Poeter Engineering
4986 Crawford Gulch Rd.
Golden, CO 80403
(303) 278-3211

This letter constitutes my review of USGS SIR 2011-5029 as you requested on Thursday, April 26, 2012

REVIEW OF GROUNDWATER MODEL PRESENTED IN USGS SIR 2011–5029

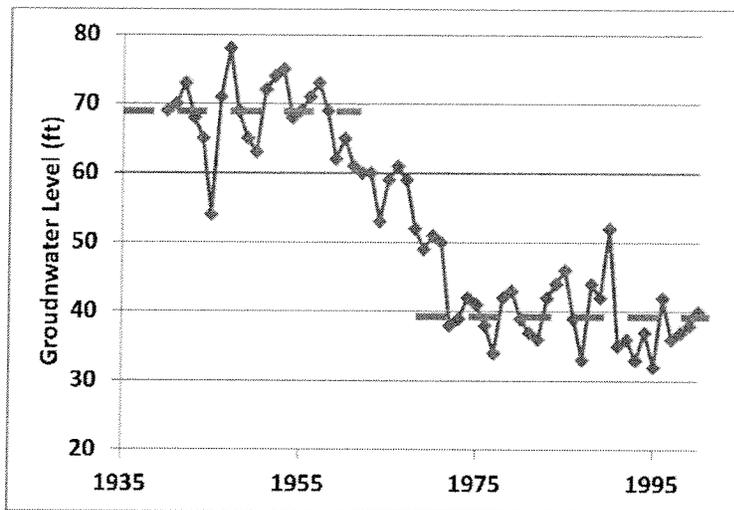
When approximating an unconfined system with a confined aquifer type in MODFLOW, the product of thickness and specific storage in the uppermost layer should equal specific yield. However, the assumed storage coefficient of 0.008 is converted to a specific storage of $8 \times 10^{-6} \text{m}^{-1}$ and applied to every cell in every layer of the model. The top layer of the model is 20 meters thick. This means that when the water level drops one meter in the top layer of the model (i.e. a one meter decline in the water table), only a 0.0002m depth of water is released. Or in English units, a 1 foot decline in the water table yields 2 one-thousandths of an inch of water.

The sensitivity of the 75 percent exceedance of stream flow to different values and distributions of storage coefficient needs to be evaluated. A lower diffusivity in the model will moderate the simulated variations in stream flow, thus would indicate that more groundwater could be withdrawn and produce the same acceptable low flow. It is likely that, like hydraulic conductivity, storage coefficient is different for the different lithologic groups. The storage coefficient of the uppermost layer needs to represent specific yield. Further modeling would need to be undertaken to evaluate the magnitude of these impacts on the 75 percent exceedance of stream flow.

- 1) Use the model to determine the influence of a higher storage coefficient on the 75 percent exceedance of stream flow for Blue River near Connerville, Oklahoma, and Pennington Creek near Reagan, Oklahoma. A model run with a homogeneous storage coefficient of 0.08 would provide insight on the potential impact of a more rigorous estimate of storage coefficient on the 75 percent exceedance of stream flow at those locations.

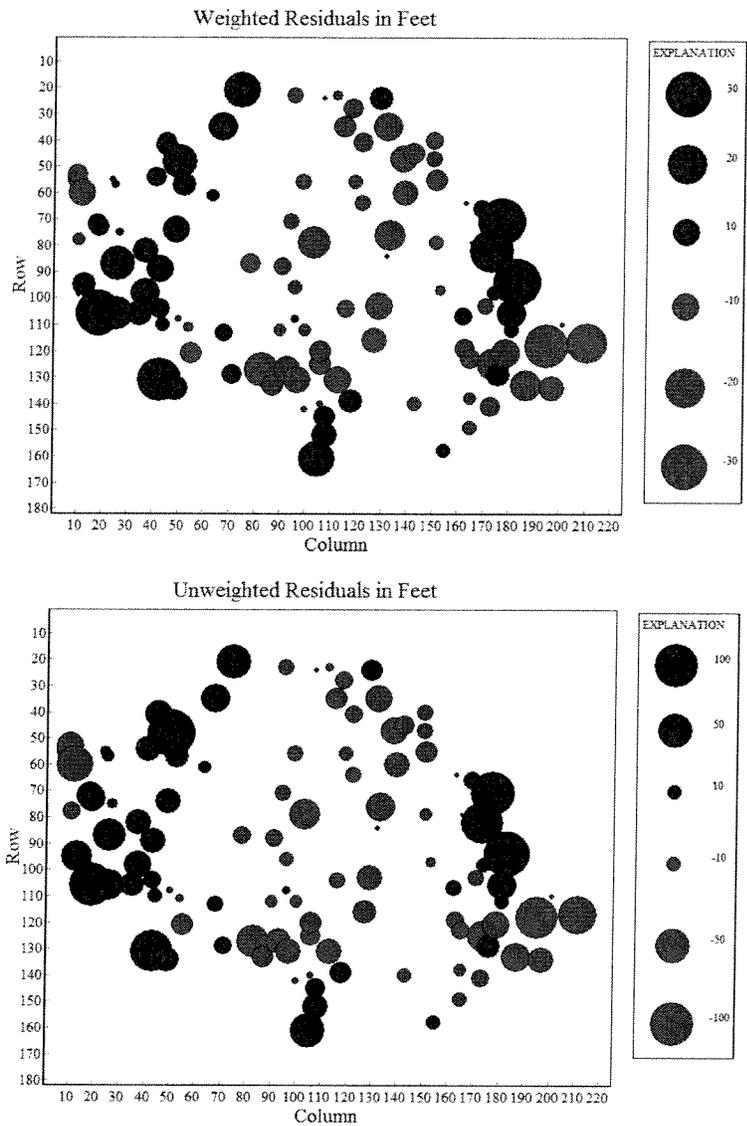
Spatial bias of residuals: Weighted residuals resulting from a model calibration should have a mean near zero, a normal distribution, and be randomly distributed in space and time. When residuals are viewed on a map, the large and small absolute values and the negative and positive values should not exhibit a pattern. This is not the case for the Arbuckle-Simpson model where negative residuals dominate the center of basin as illustrated in figure 33 of the report and emphasized in the figure below by showing negative residuals as red and positive as blue. Residuals are calculated as the observed value minus the simulated value. So a negative residual indicates the simulated head is higher than the observed head. Thus, generally the heads are too high in the central portion of the model domain and too low on the perimeter. This bias should be corrected. Further modeling would be required to determine how this affects the predicted flows or the report conclusions. To facilitate

direct comparison between the observed and simulated heads, the unweighted residuals are also shown with a different bubble size as indicated in the legends. The weights are the same on all head observations except the few that are non-synoptic in the post-Simpson unit and those heads have half the weight of the rest of the heads. So the primary difference between the plots is the decrease in residual due to the weights being less than one.

- 8) Evaluate the cause for spatial bias of the residuals and make appropriate adjustments to the conceptual model.
- 9) Conduct a calibration that includes both steady and transient simulations. The steady situation could be a calibration to average annual conditions followed by a warm-up period with no observations followed by the 2004-2008 transient calibration period.
- 10) Include all available heads and flows as observation targets in the transient portion of the calibration.
- 11) Include storage coefficient as a parameter in the transient calibration.
- 12) More transient head data may be necessary to obtain a reliable transient calibration and such data collection should begin as soon as possible.
- 13) Evaluate prediction sensitivities.
